# Video Products Technical Bulletin 30-2008-107

SUBJECT: POWER CANNOT BE TURNED ON

MODEL: **BVM-20M4DE**  
**BVM-20M4E**  
**PVM-20L4**  
**PVM-20M4A**  
**PVM-20M4E**  
**PVM-20M4U**

Figure 1

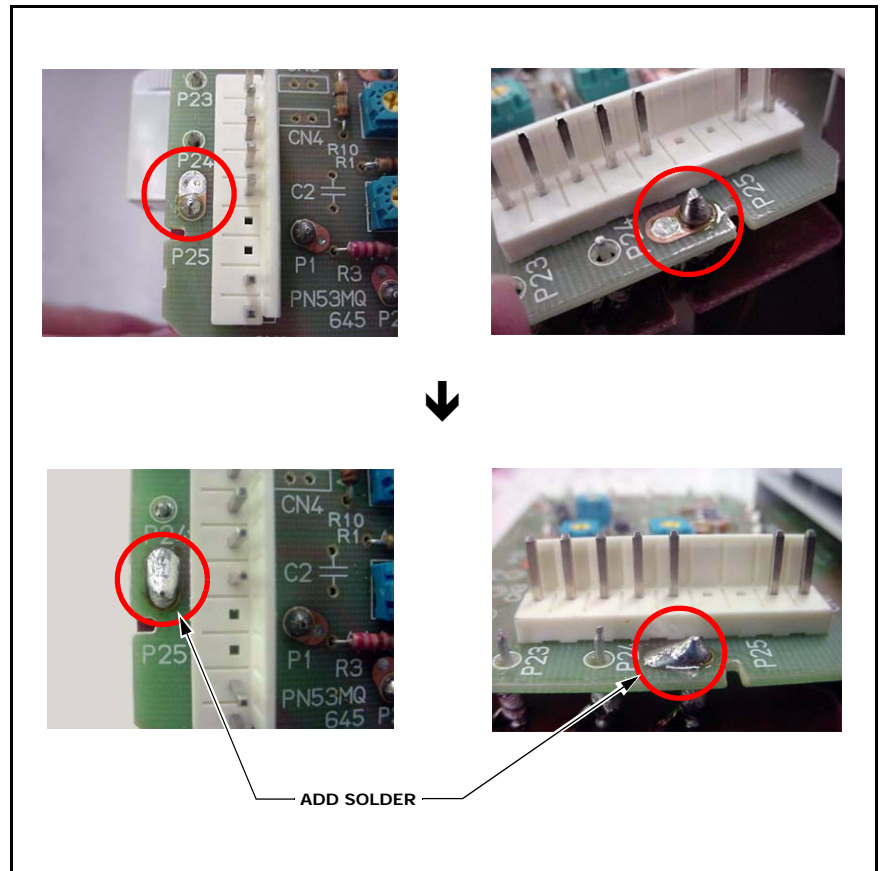
If the DY block overheats after servicing, power cannot be turned ON.

To prevent the symptom, apply additional solder to the pin on the board of the DY block as shown in Figure 1.
